EIA for Proposed Modified Namakwa Sands EOFS Project Residue Disposal Plan

Notes for Authorities Meeting: DHSWS

Held: Microsoft Teams, 30 July 2020 at 10h00

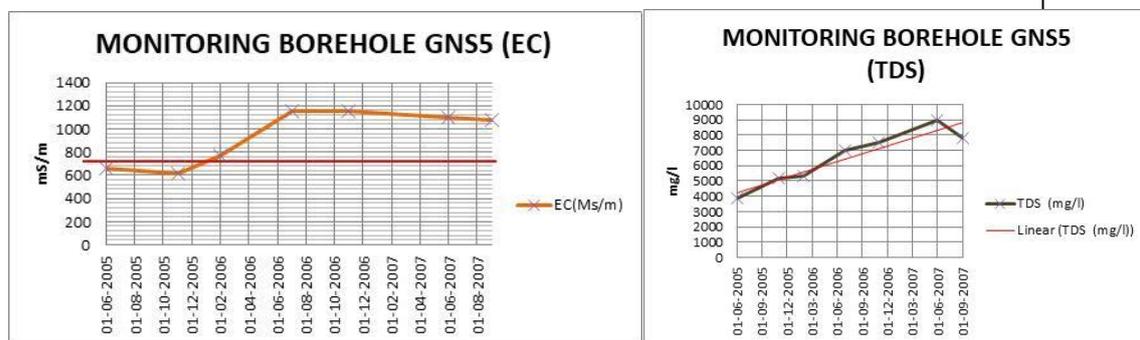
RN noted concerns that mining to 35 m and backfilling in discrete areas rather than across the pit will increase salt concentration deposited in a smaller area and referred to borehole monitoring data provided below:

If moisture of backfill is 18% then it equals 1 274 litres of seawater per m² for 4 m thick backfill. If moisture of backfill is 18% then it equals 12 740 litres of seawater per m² for 40 m thick backfill.

ML noted in response that mining is proposed to 7 m, though authorised to 35 m. The query is also addressed in the groundwater model outcomes, which follow.
